Town of Seekonk, MA Planning Board

DEFINITIVE PLAN REVIEW

Jacob Hill Estates – Plat 17, Lot(s) 79 – Off of Taunton Ave & Jacob St

RE: REVIEW OF DEFINITIVE SUBDIVISION PLAN DATED OCTOBER 22, 2013
JACOB HILL ESTATES, TAUNTON AVENUE & JACOB STREET, SEEKONK, MA

7 TYPICAL ROADWAY SECTION
NOT TO SCALE

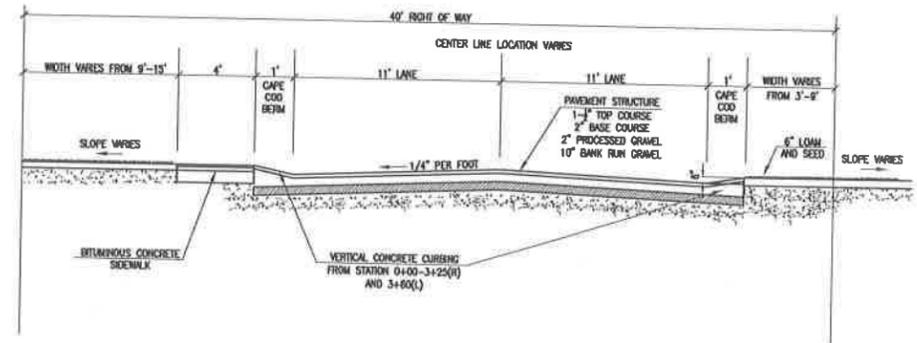
3. The applicant has requested a waiver for the proposed street width of 22 feet.
 - a. The detail on Sheet 11 showing the typical roadway section has been revised to show the 22-foot width and the provision of a sidewalk. However, the dimensioning of the landscaped portions of the right-of-way should be corrected to correspond to this change.
